World Forum for Harmonization of Vehicle Regulations**Working Party on Passive Safety Provisions****Seventy-first session**

UN Regulation No. 129 (Enhanced Child Restraint Systems)**Proposal for Supplement 8 to the 03 series of amendments****Submitted by the expert from the Netherlands***

The text reproduced below was prepared by the expert from the Netherlands on behalf of the Ad-Hoc group on Annex 25 (Spain, Germany, Netherlands, TSG, CLEPA, Safesign, Advanced Safety Concepts) to amend the existing procedure that measures the prescriptions of the minimum sitting height for booster cushions. The modifications to the current text of the UN Regulation are marked in bold for new or strikethrough for deleted characters.

Figure 2
Ruler of Measurement Device

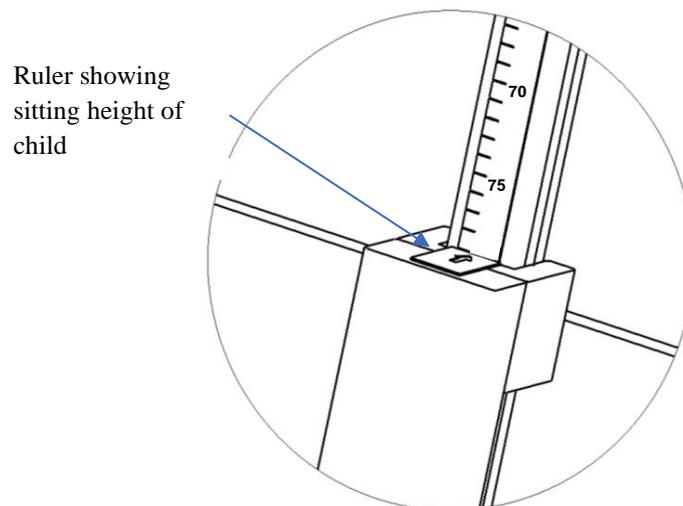
- (f) ~~The measured distance between the two points M and N (Figure 1) represents the sitting height of a child who will use the booster cushion.~~ The corresponding value **of the sitting height** is displayed by a ruler that is provided with the device as shown in Figure 2.
- (g) Using the data in Table 3, the sitting height is utilized to determine the corresponding minimum stature of the child that can be accommodated by the booster cushion. Example: A sitting height of 66.2 cm shall correspond to a child minimum stature of 125 cm; a sitting height of 75.9 cm shall correspond to 150 cm.

In case the value obtained for the sitting height is between two integer values always round up to the next integer value (e.g. Measured sitting height = 70.1 cm ► resulting stature = ~~135.65~~ **136.05** cm ► Smallest stature allowed = ~~136~~ **137** cm).
- (h) The stature determined in this procedure shall be compared to the lower limit of the approval stature range. The requirement is fulfilled if the lower approval stature is greater or equal than the obtained minimum stature.

Device to measure the booster cushion height

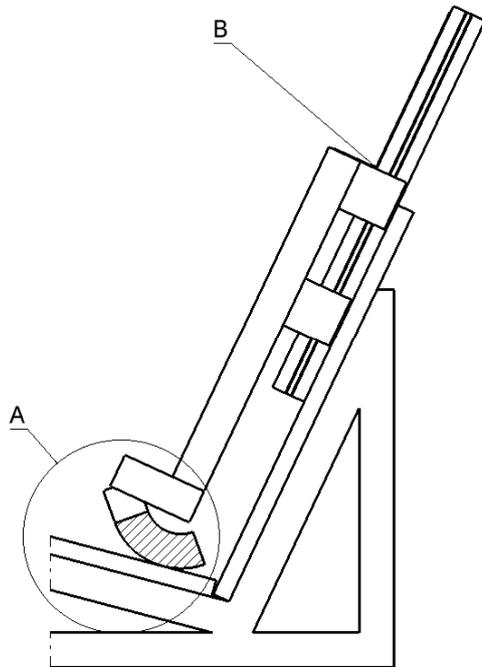
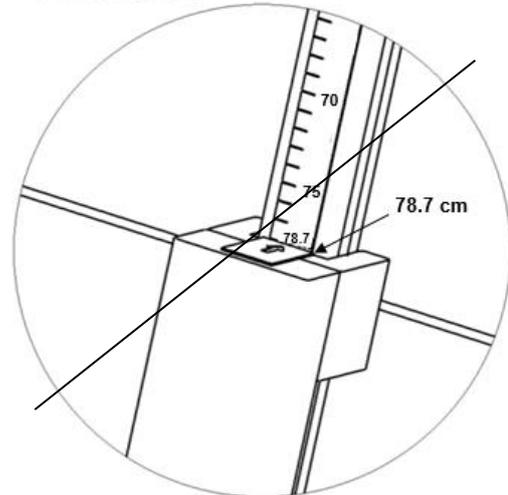
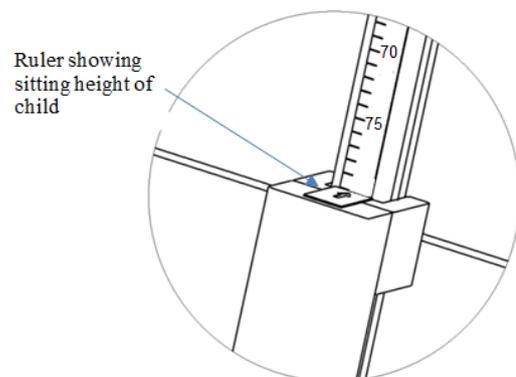
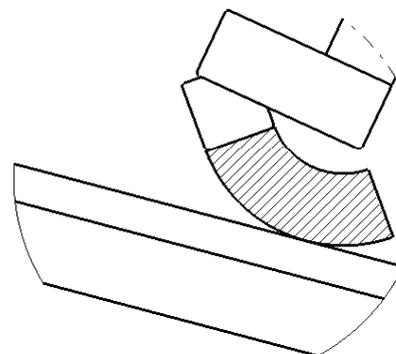
To calibrate the ruler of the measurement device, its structure shall contact the supporting surface (Detail A). In this configuration, the scale shall show the calibration value of **78.7** **79.7** cm (Detail B).

seated on the test bench, the top of the head is 77.0 cm from the Cr axis. The nominal sitting height of the dummy is 78.7 cm. **Taking this value as a reference, when translating the value to the 80 mm distance from the test bench backrest where the sitting height of the child is measured, and taking into account the different angles in between the backrest, the horizontal plane and the head position, a value of 79.7 cm is used as the calibration value.**

II. Justification

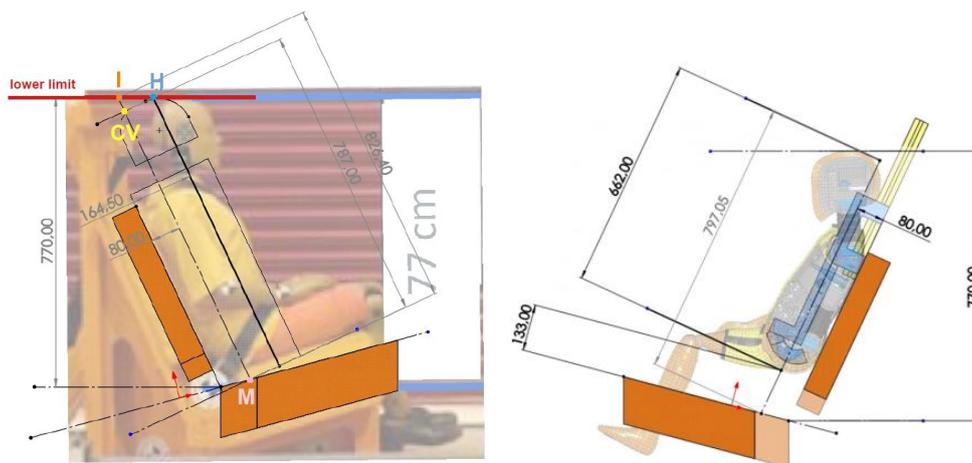
1. Paragraph 6.1.3.6. states that the top of the head of the child must lay at or above a horizontal plane located at 770 mm above Cr.
2. However, there is an inconsistency between the method described in the main body of the existing text and the measurement device described in Annex 25. Paragraph 6.1.3.6. has therefore been amended to remove this conflict.
3. Virtual verification of the calibration value stated in Annex 25 has shown a 10 mm error. This error occurred because there are different distances to the test bench backrest between the 5th percentile female anthropomorphic test device and the Q dummies. It is therefore proposed to increase the Annex 25 calibration value by 10 mm.

4. The calculation in paragraph 6.1.3.6. (g) was incorrect since it came from a linear regression using all of the table values instead of using linear interpolation between the two nearest values in table 3, as it is mentioned in the Note.
